The main issues in the assessment of this application are:

3.0 DESCRIPTION OF THE PROPOSAL

Figure 5: Image showing sightlines from Levels 3 and 4 toward Alma

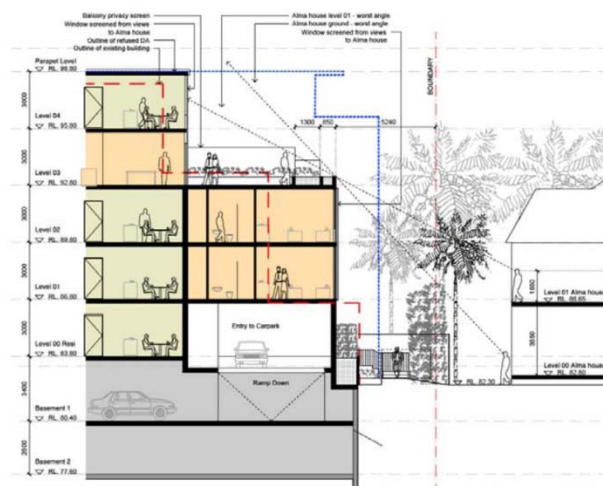
Privacy mitigation measures including fixed aluminium louvres and terracotta baguette screens are proposed on the elevation of the residential flat building facing Alma to provide visual privacy to this property. In addition to the measures shown on the plans, it is recommended that units 2.15 and 3.14 also be provided with terracotta baguette screens on this elevation.

Alma and the private open spaces areas of units 3.12 and 3.14 located directly beneath the subject balcony.

The applicant has submitted a section drawing (shown below) which demonstrates that overlooking of Alma from the two balconies on Level 3 of the residential flat building will not be unreasonable.
